ADDENDUM

JLG 24146-5 Dunn County Courthouse Renovation

Issued: November 7, 2025

ADDENDUM #: 02

2 M402 FIRST FLOOR PLAN - AREA B - BASE BID DETAIL
1/4" = 1'-0"

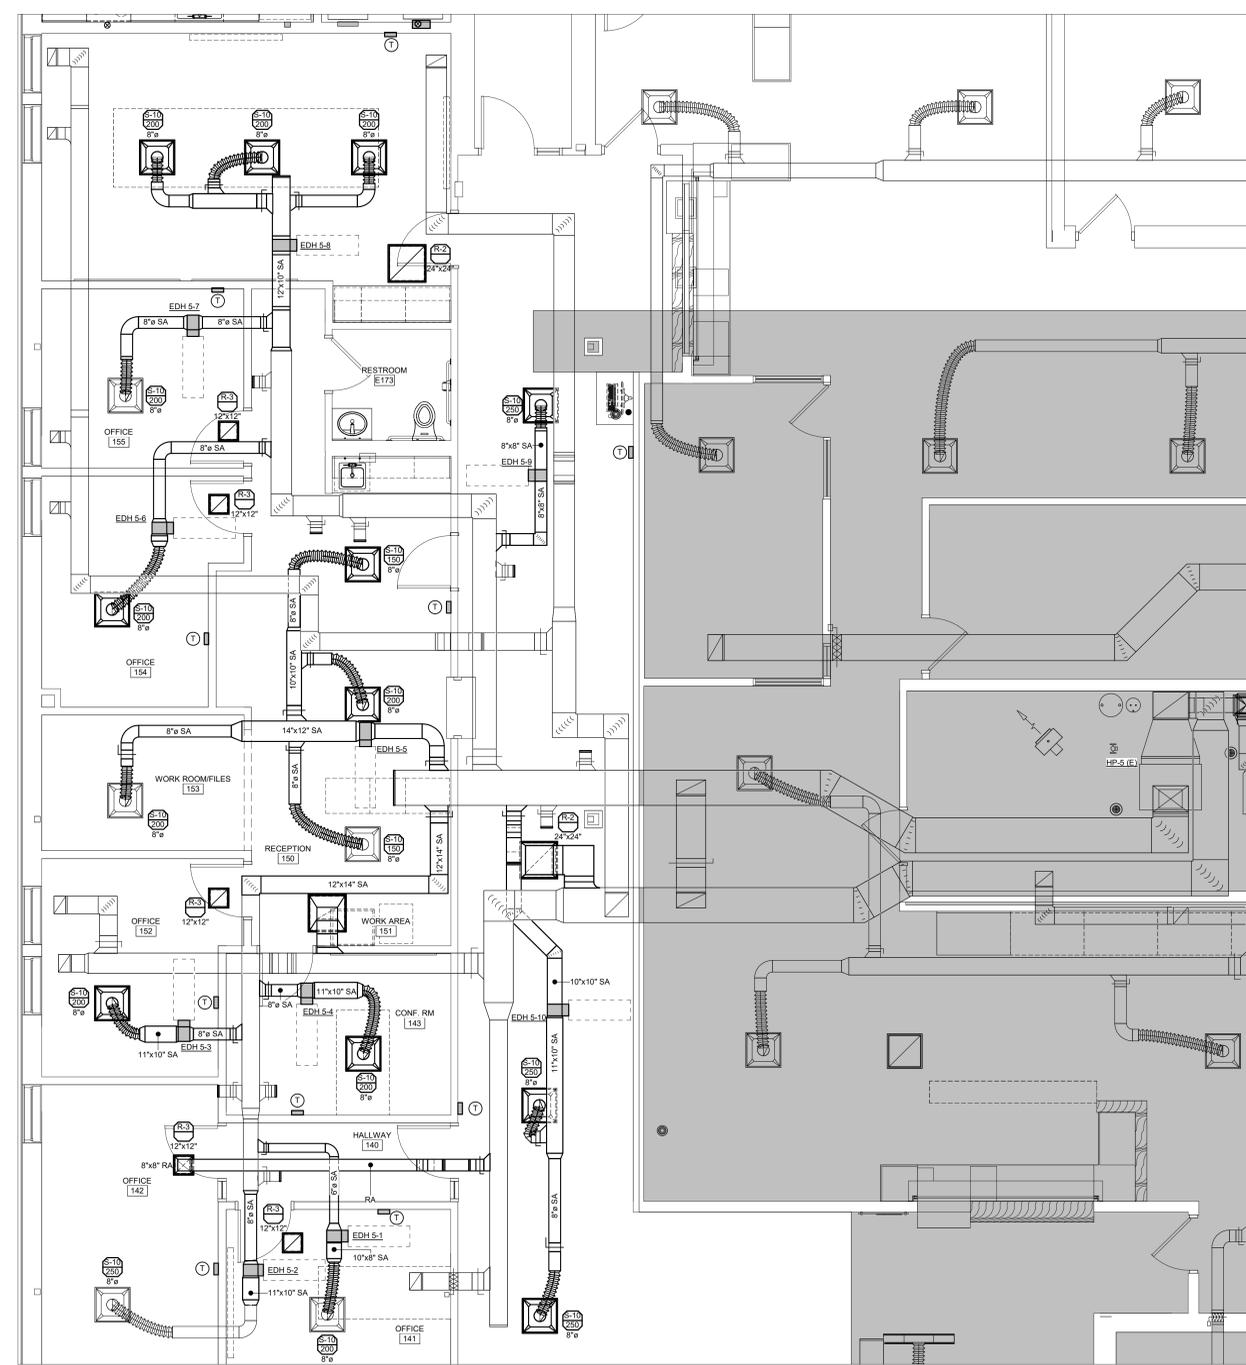
1. M402 – FIRST FLOOR PLAN HVAC
 - o SCHEDULE 238000 – ELECTRIC DUCT HEATER SCHEDULE
 - Modified electric phases for electric duct heater elements.
2. M600 – SCHEDULES
 - o SCHEDULE 224000 – PLUMBING FIXTURE SCHEDULE
 - S-1 FIXTURE CHANGED TO MODEL LRAD 331955

2
E101
Existing First Floor - Area B
1/8" = 1'-0"

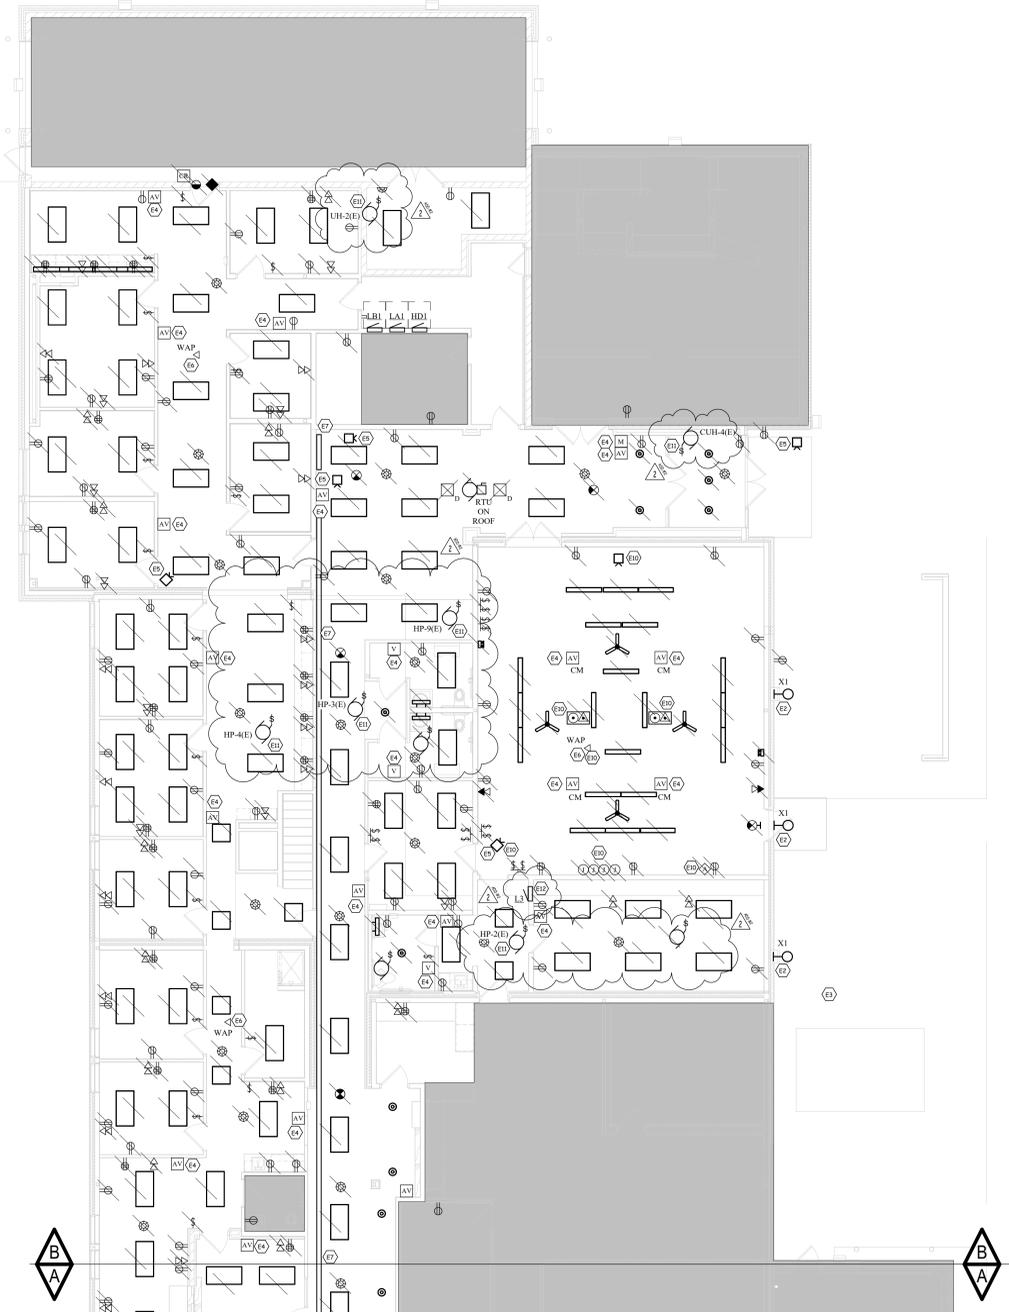
1. E101 – EXISTING LEVEL 1
 - o Drawing 2/E101: Updated mechanical equipment that is to be reused. Updated keynote E6 and E11. Added keynote E12
 2. E102 – EXISTING LEVEL 2
 - o Drawing 1/E102: Updated keynote E6.
 3. E201 – LEVEL 1 LIGHTING PLAN
 - o Drawing 2/E201: Removed exhaust fans (EF-1, EF-2, EF-3, and EF-4).
 4. E301 – LEVEL 1 POWER PLAN
 - o Drawing 1/E301: Updated electric duct heaters. Added EDH-9 and EDH-10. Updated keynote P22.
 - o Drawing 2/E301: Updated electric duct heaters. Updated mechanical equipment that is to be reused. Added keynote E27
-

1 Power Plan - Second Floor - Area A
1/8" = 1'-0"

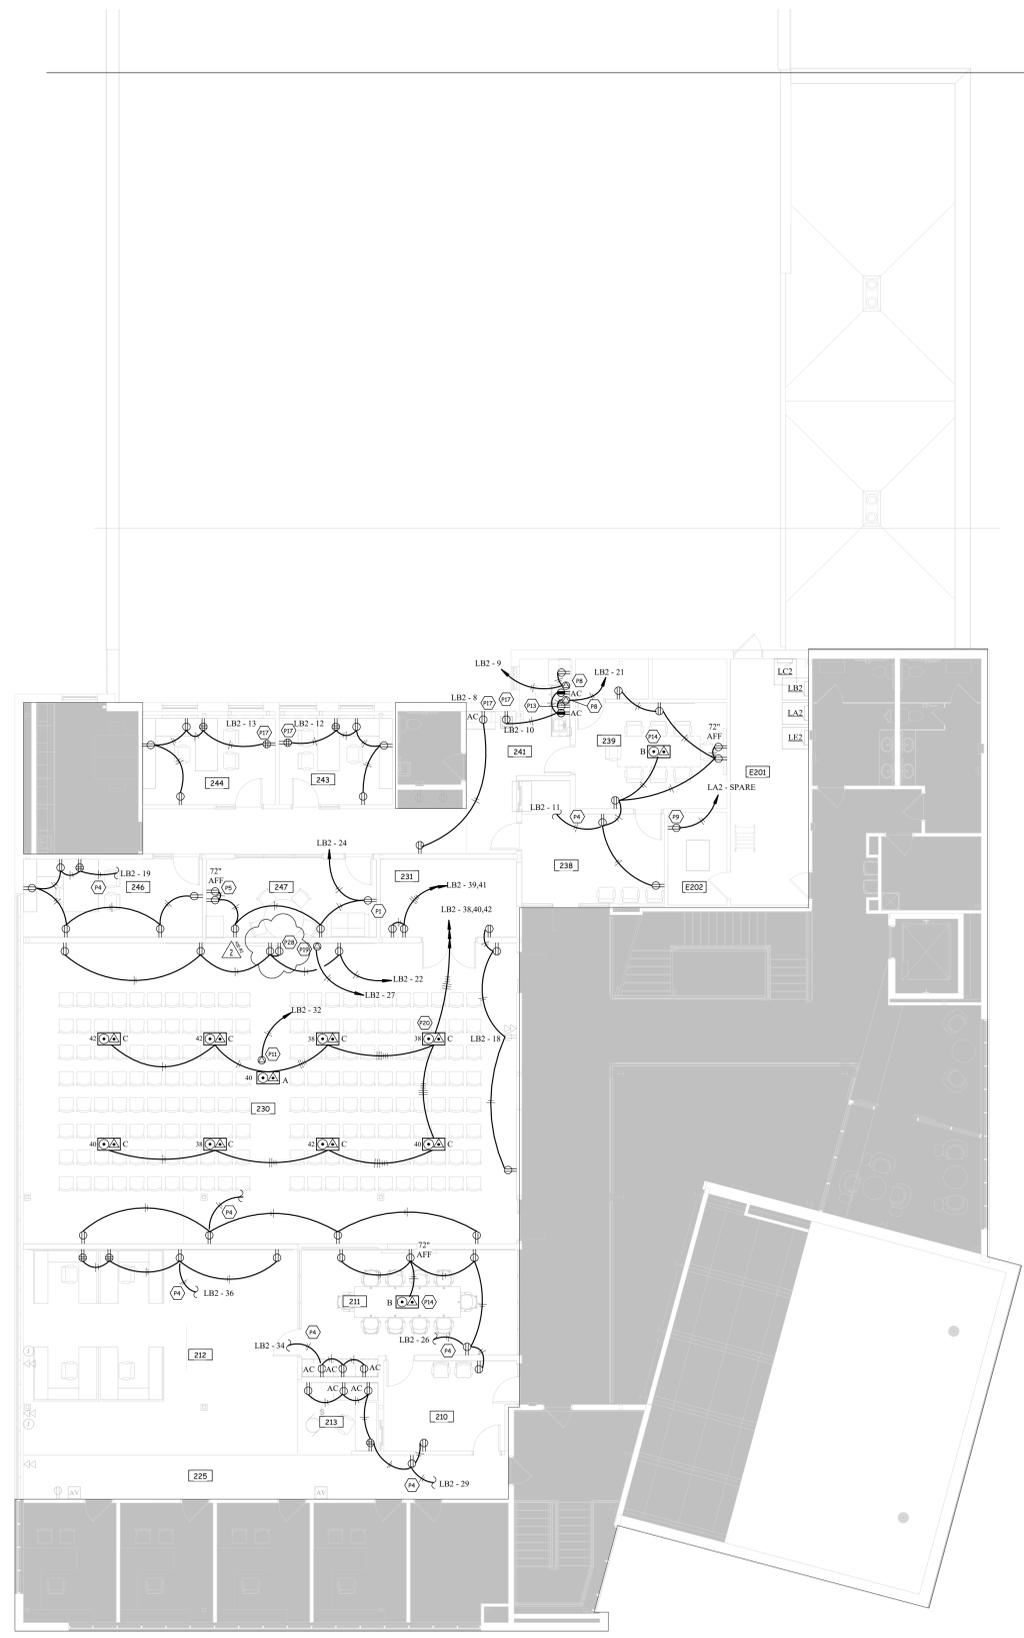
- Drawing 1/E302: Added receptacle for TV and keynote P28.
- Motor & Equipment Schedule: Updated equipment to match the mechanical drawings.

1
E402
Systems Plan - Second Floor - Area A
1/8" = 1'-0"

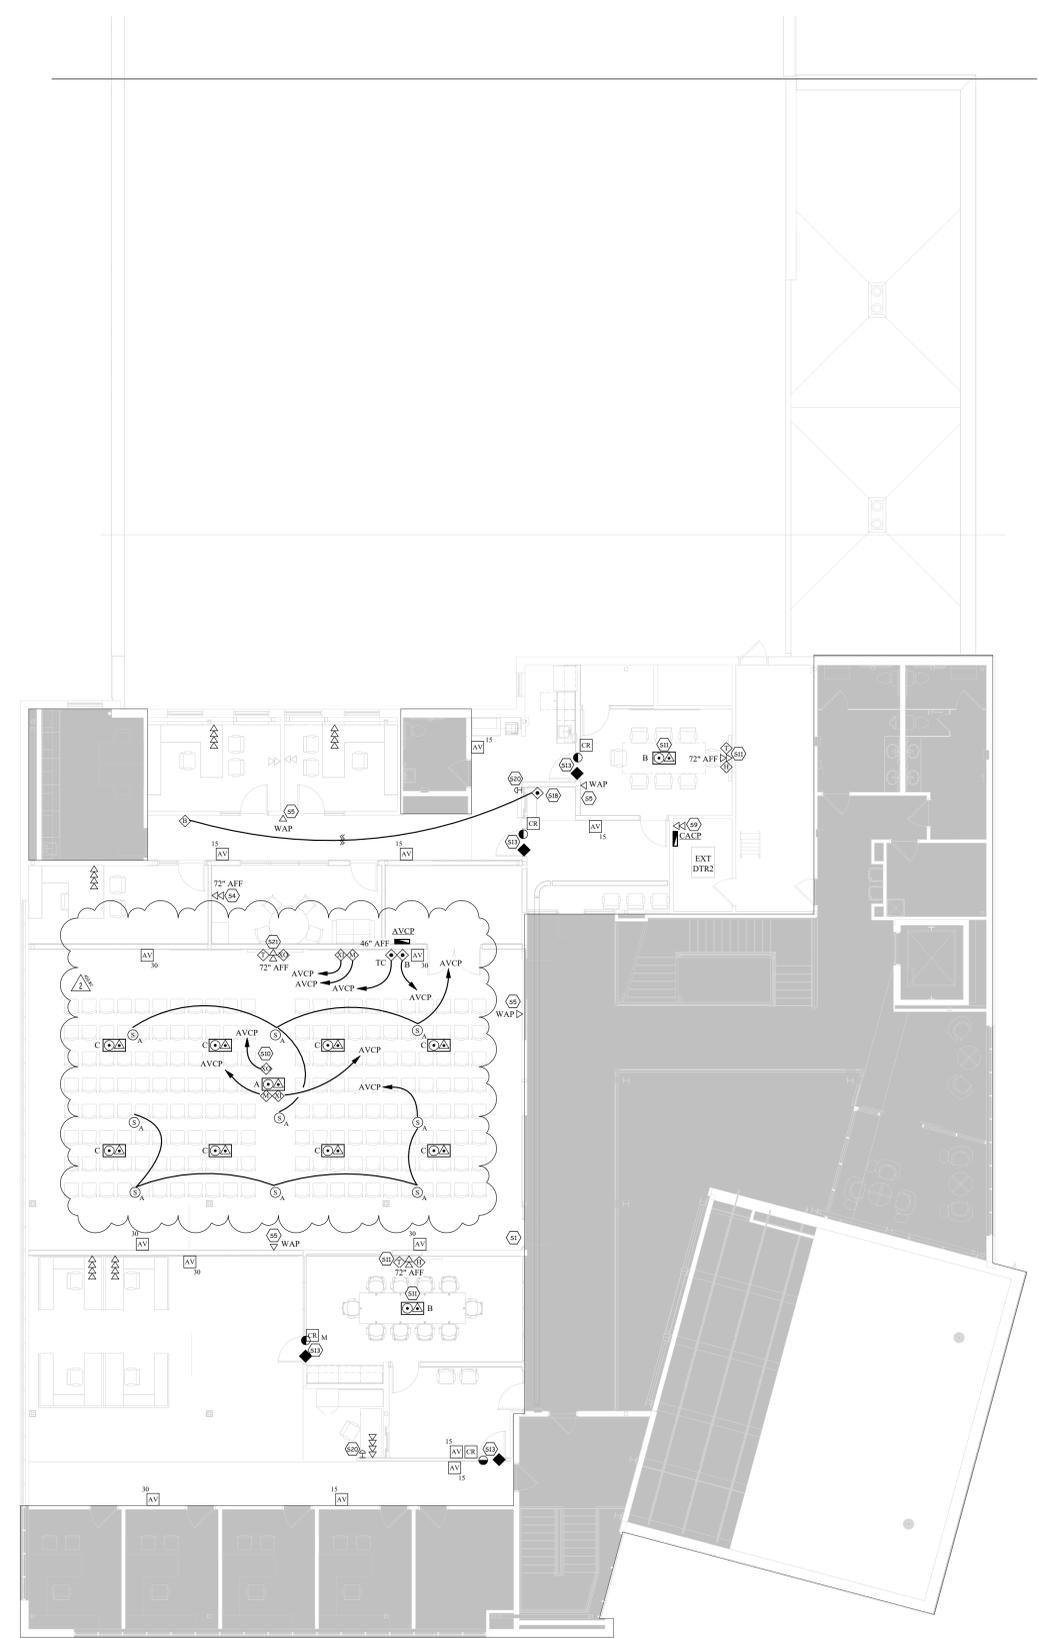
- Drawing 1/E402: Updated the large meeting room multimedia system, added devices, and added keynote S21.
